ADDENDUM NO. 2

Kau Water System Improvements – Phase 1

IFB No.: IFB-20-HHL-019

DWS. NO.
C-3
SHEET 5 OF 54

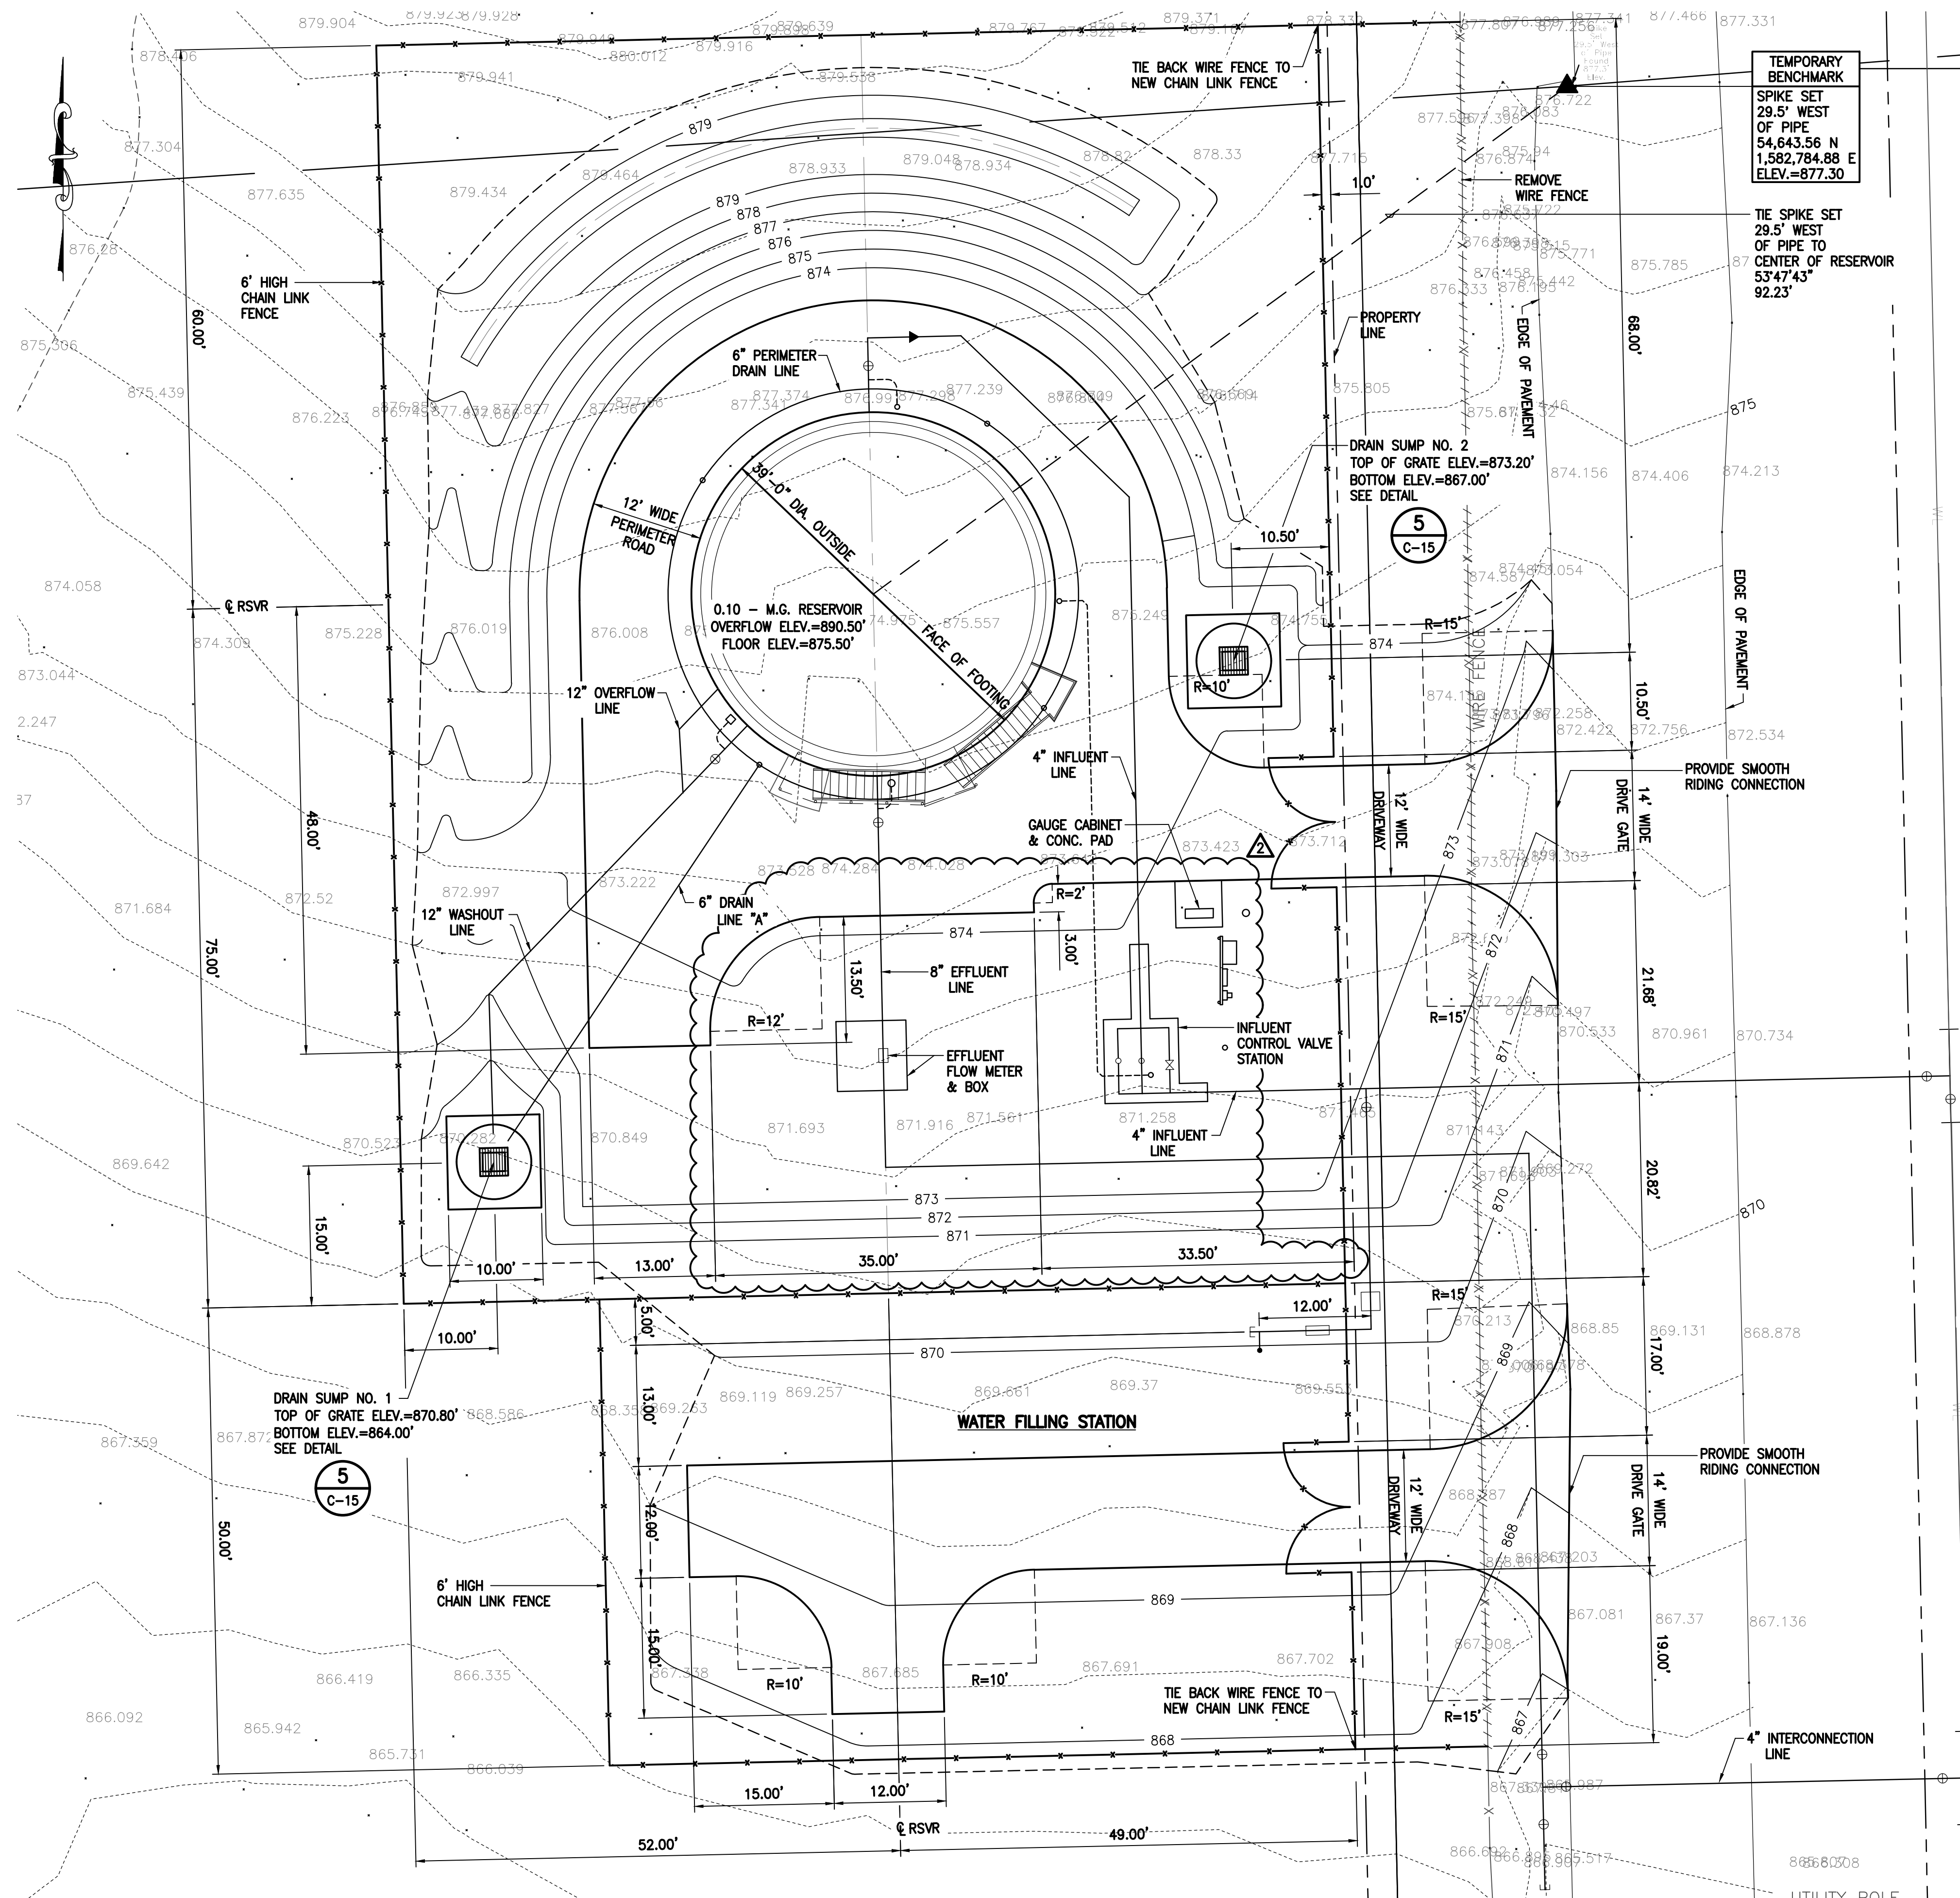
1. PLANS: Drawing No. C-3 - Revisions include showing the electrical service equipment; showing the reservoir exterior stairs; and widening the AC pavement at the vicinity of the reservoir exterior stairs.

DWG. NO.
C-4
SHEET 6 OF 54

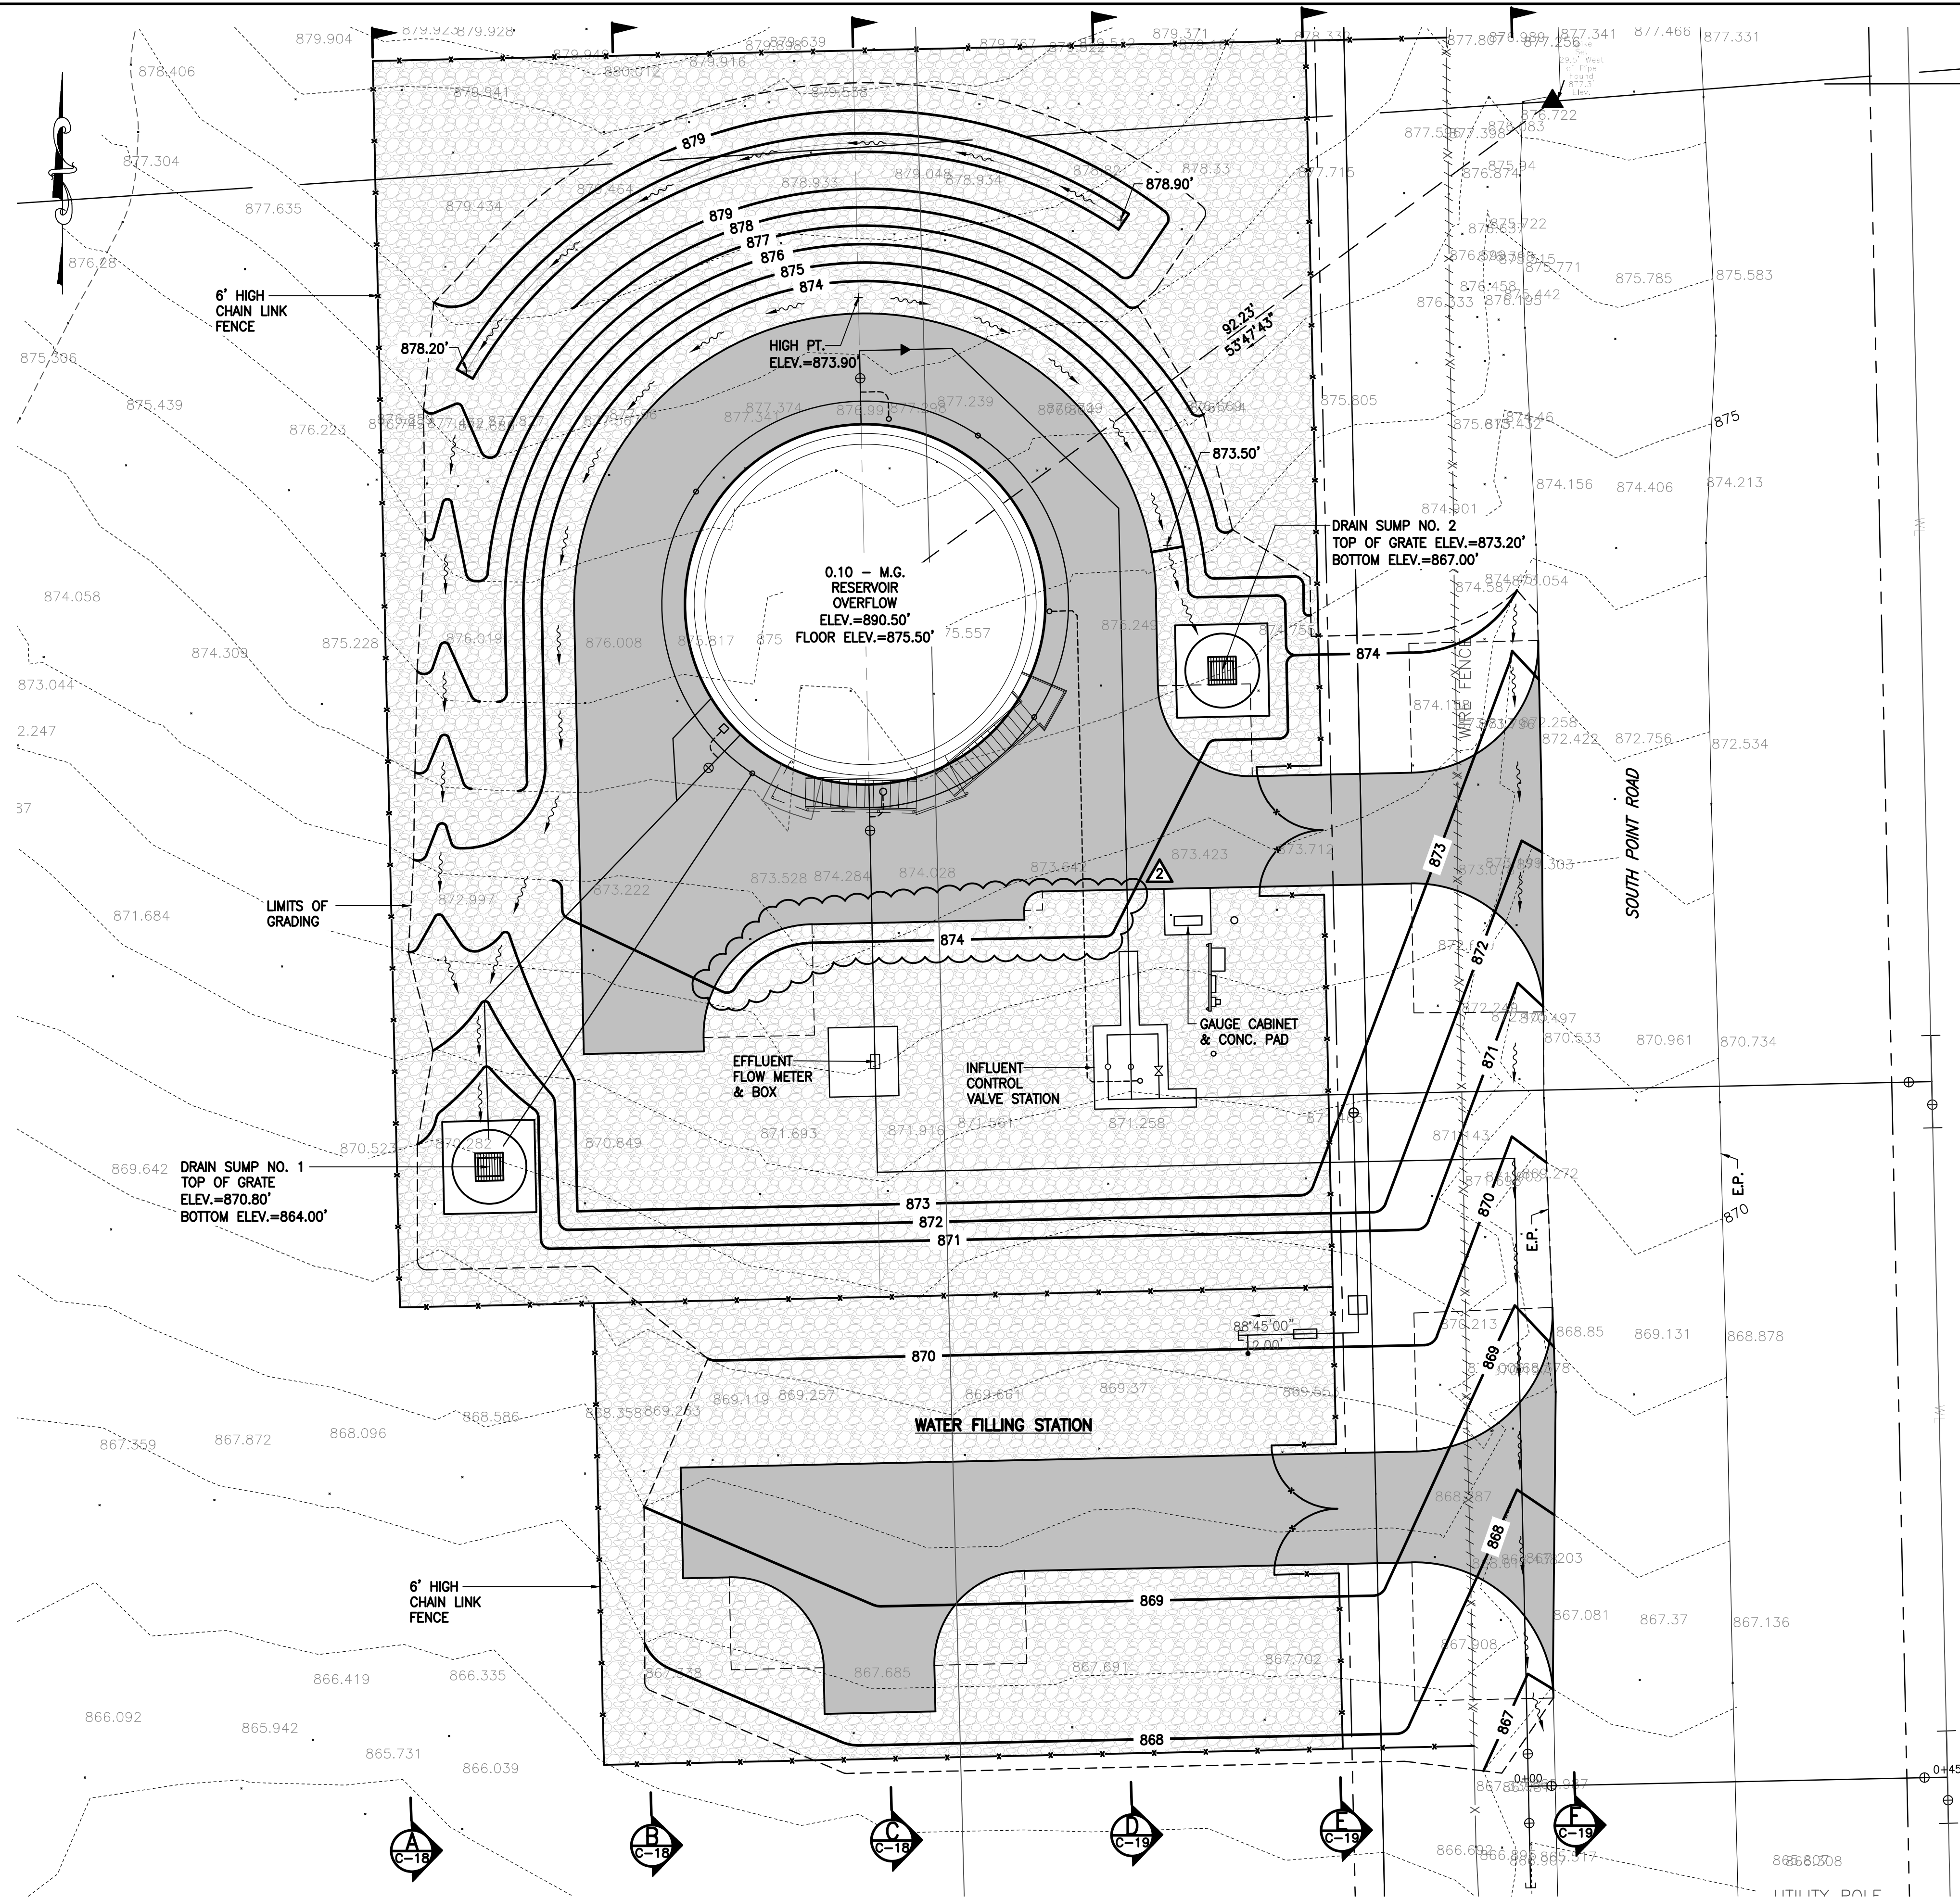
2. PLANS: Drawing No. C-4 - Revised grading where AC pavement was widened near reservoir exterior stairs.
3. PLANS: Drawing No. C-5 - Revisions include revising the alignment of the 8-inch reservoir effluent line; revising the layout of the 1-inch service lateral for the water filling station; relocating the reservoir level transmitter; relocating the water sampling station at the effluent line; deleting the concrete thrust beam on the reservoir effluent line; replacing the Toshiba flow meter on the effluent line with a Krohne flow meter; and adding one 8-inch gate valve with valve box and one 4-inch gate valve with valve box at the 4-inch interconnection line.

DWG. NO.
C-9
SHEET 11 OF 54

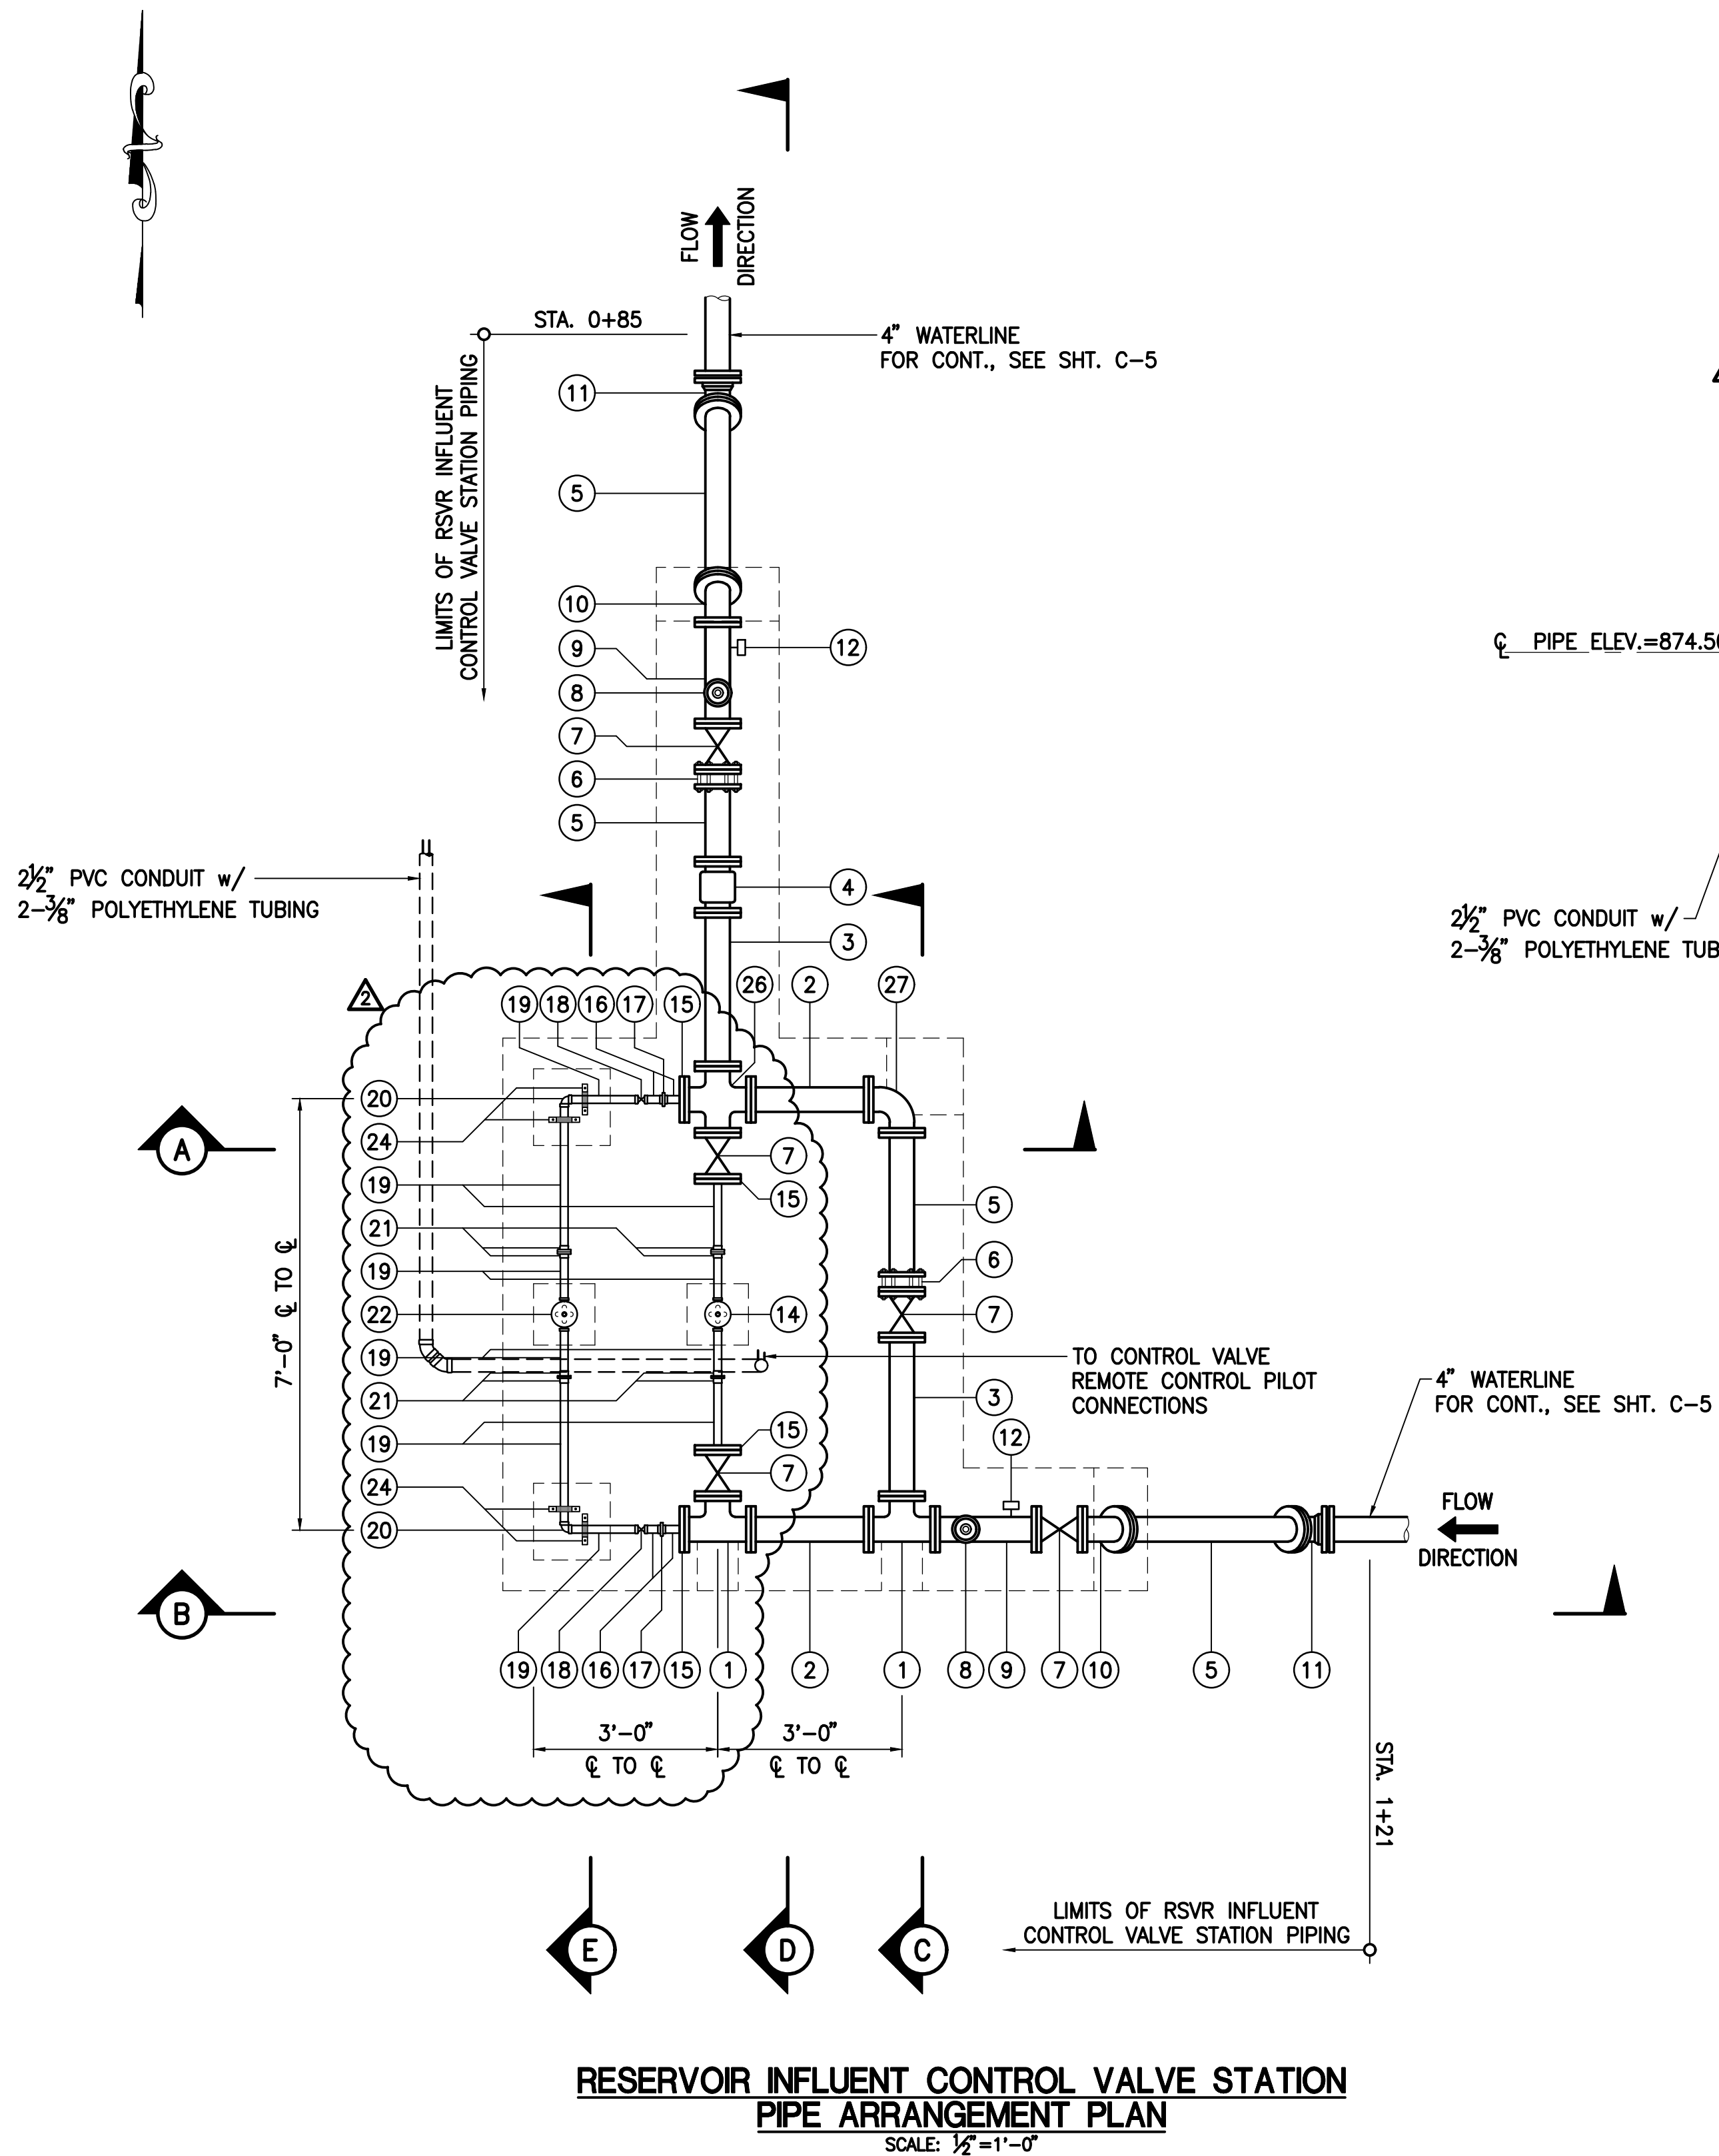
5. PLANS: Drawing No. C-9 - Revisions include removing the 1-1/2 – inch combination pressure relief and solenoid control valve and associated piping; reducing the size of the combination pressure relief and remote control valve from 4-inch to 1-1/2 – inch along with associated piping including the addition of two 4-inch ductile iron blind flanges with 1-1/2 – inch IPT taps; remove five straps for 4-inch pipes; add three more hold down clips for 4-inch pipes; replace the Toshiba flow meter at the influent control valve station with a Krohne flow meter.
